Subject: Description of Permissive Change

FCC ID: 2AK23MC120

Model Name: MC120LT,MC120BS.

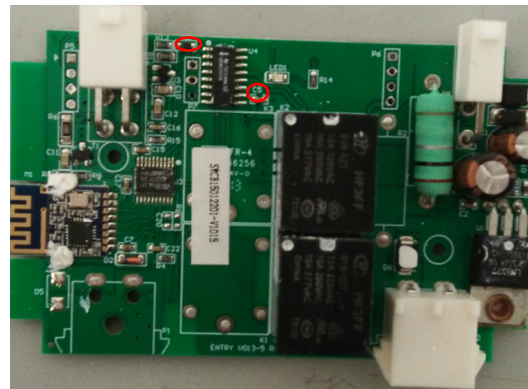
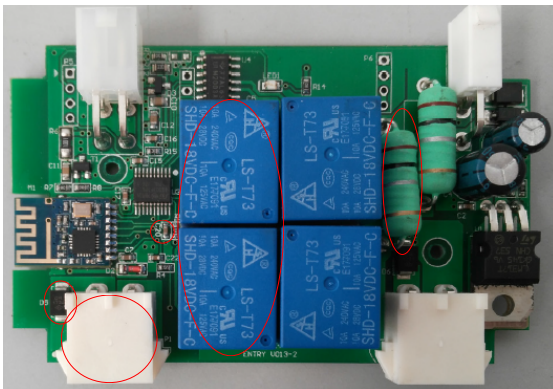
1. Change the model form MC120LT, MC120BS to MC120, MC120BK, MC120BA, MC120SP, MC120LB, MC120LS, MC120TS, MC120SG .
2. The board is different:  
(1)Removed: K1, K3, R2, C20, P1, D5 .  
(2)Added:D7,C5.
